Keylabs Inc

Cypherock X1 Audit

Executive Summary

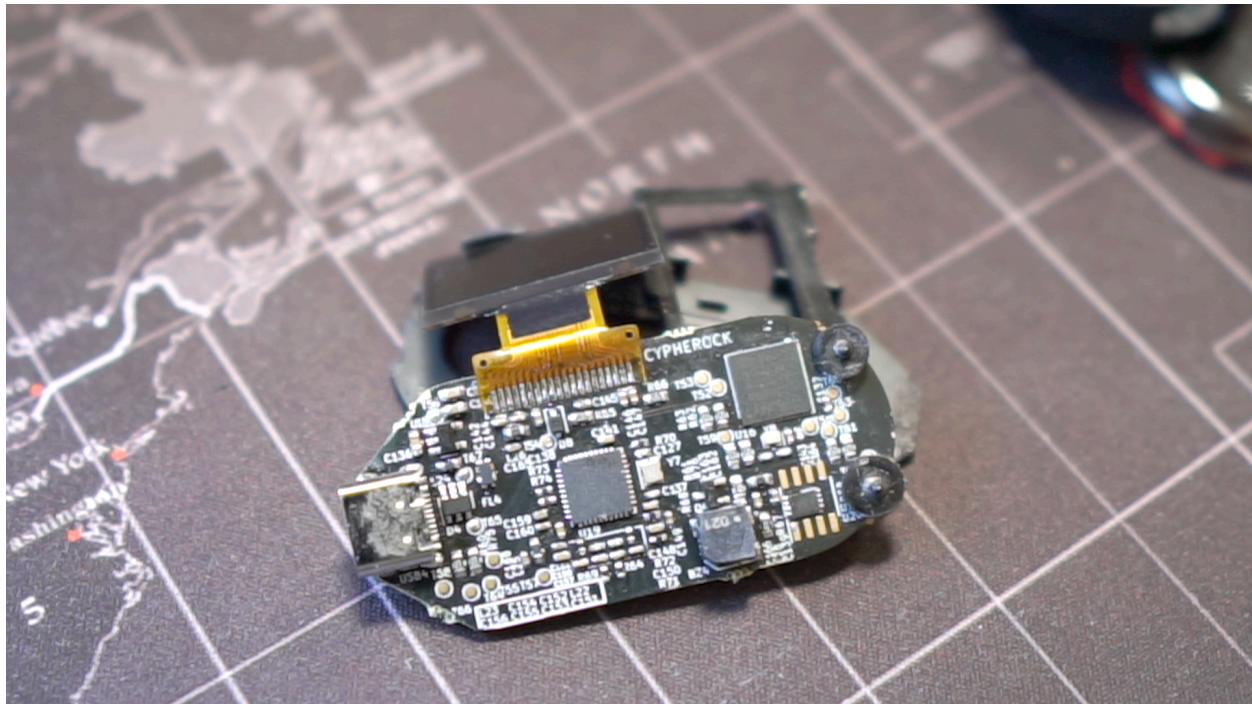
There are numerous test points on the devices that are visible leads to all the relevant communication between the main microcontroller, the NFC interface and the ATECC. Though not directly exploitable, such test points do make it significantly easier to sniff and interface the device. More importantly such test points can be utilized to build a programming jig that can quickly and easily interface with the device as part of a physical evil maid attack and/or as part of a supply chain attack. Interfacing to an already manufactured device is so straightforward that it may be difficult to detect such malicious access as part of a forensics analysis by the manufacturer or the user.

The ATECC608A has two footprints on the device. Essentially, the larger footprint is even more accessible and easy to access, effectively providing test points for the ATECC608A and further reducing the amount of effort required to interface to the device. Since the larger package is not used on the device, the larger footprint pinout should be removed.
